Subject: MHI's Responses to US-APWR DCD RAI No. 212-1950

Responses to Request for Additional Information No. 212-1950,
Revision 1

**US-APWR Design Certification
Mitsubishi Heavy Industries
Docket No. 52-021**

RAI NO.: NO. 212-1950 REVISION 1
SRP SECTION: 03.07.02 – Seismic System Analysis
APPLICATION SECTION: 03.07.02
DATE OF RAI ISSUE: 02/25/09

Fig.19.4 Comparison of ISRS for NASTRAN and ANSYS FE CIS models (EW Direction)
 (Sheet 3 of 5)

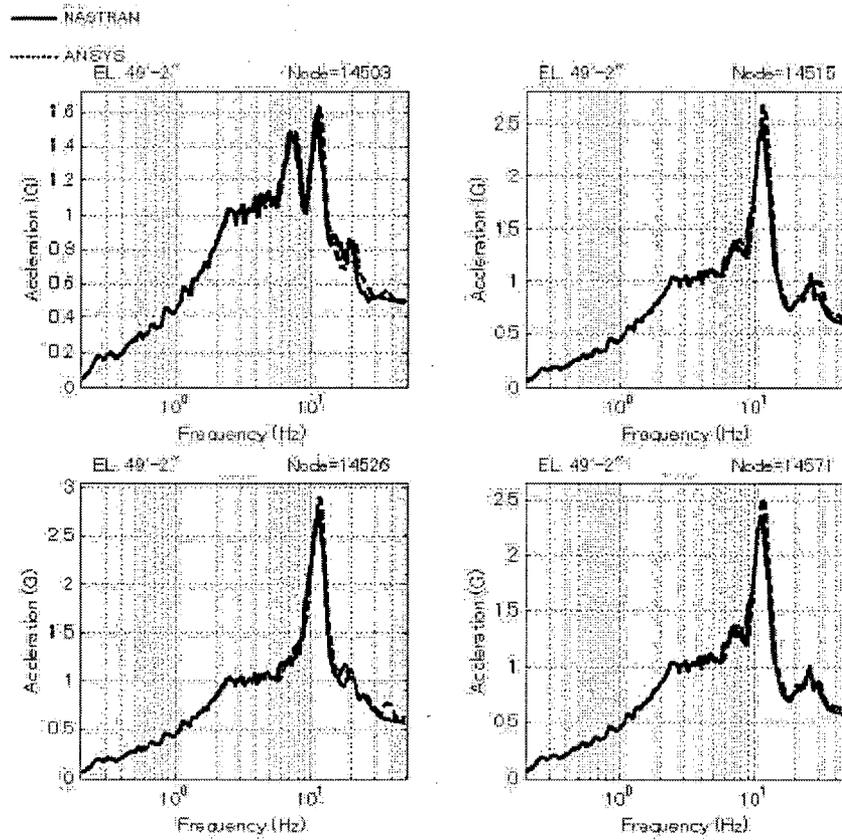
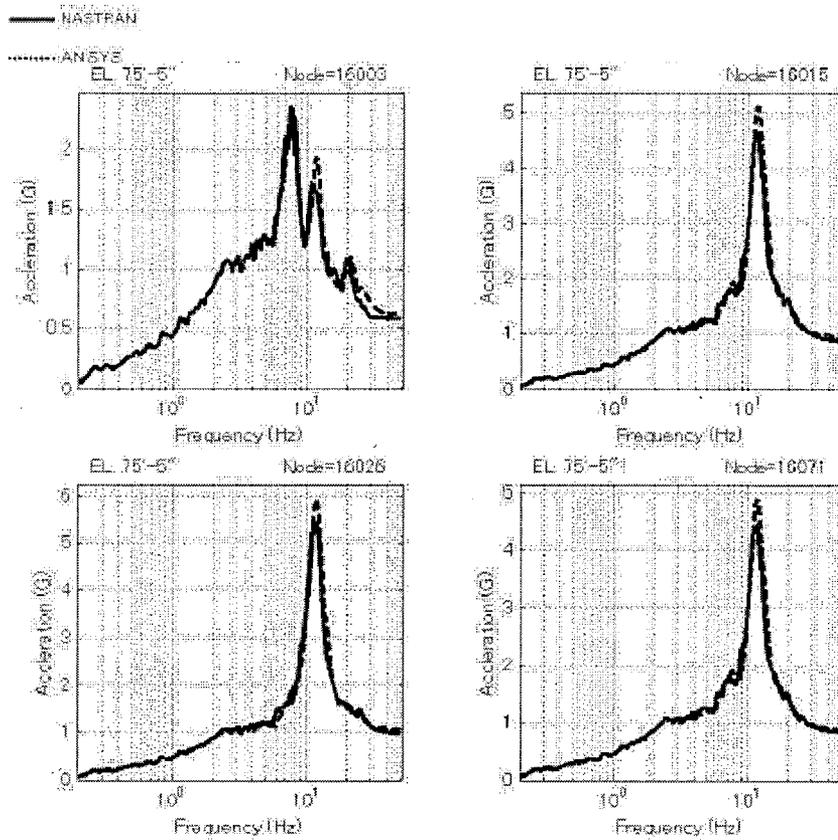
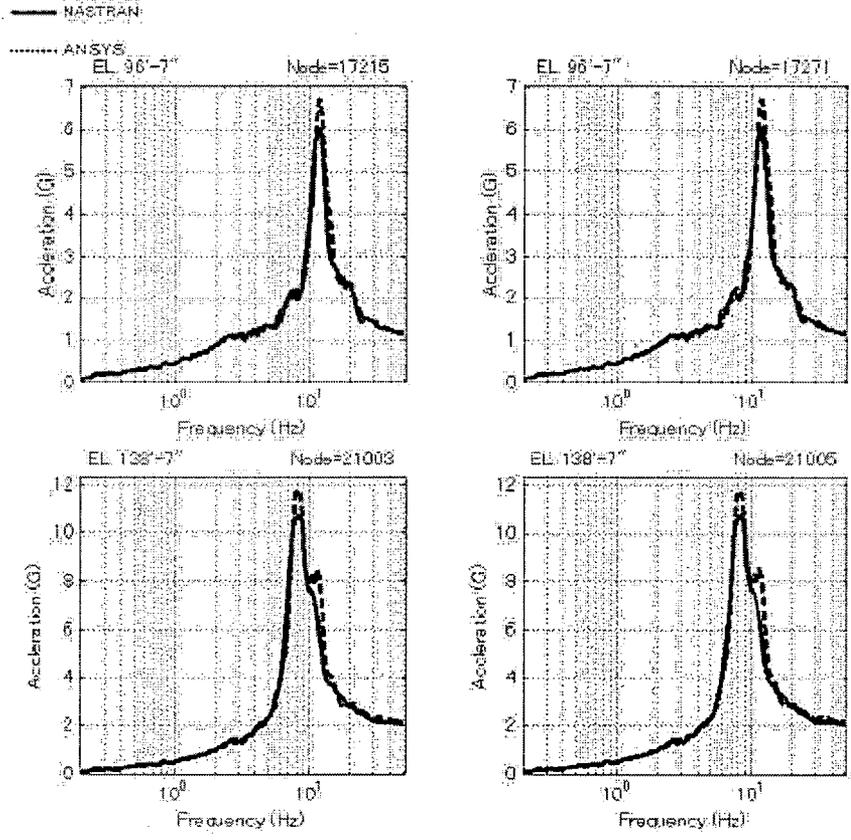
In Section 3.7.2.3.1 of the DCD it is stated that the NASTRAN finite element models are used for validation of the dynamic lumped mass stick models and the NASTRAN results are validated by comparison to the results of separate ANSYS finite element model analyses. Provide results and details of the NASTRAN and ANSYS validations. Describe how the various finite element models that were developed for validation meet the guidelines of SRP Sections 3.7.2.II.3.C.ii and iii.

To verify whether the dynamic properties of the NASTRAN FE model conform to those of the ANSYS FE model, the 5% damping ISRS are calculated at several node points in both models that represent main floor levels. The points selected for validation are shown in Figures 19.1 and 19.2 (below) and Tables 19.1 and 19.2 (below) which are the same points selected in Subsection 3.7.2.3.10 of the DCD.

As stated in the response to question RAI 3.7.2-8 of this RAI, ISRS which incorporate the effects of local vibration modes will be provided in Revision 2 of the DCD. The revision will meet the guidelines of SRP Section 3.7.2.II.3.C.iii.

Further results and details of NASTRAN and ANSYS FE model validations will be provided in Revision 2 of the DCD. The response previously submitted for RAI 212-1950, Question RAI 3.7.2-8, states the ISRS, considering local vibration modes, will be provided in Revision 2 of the DCD.
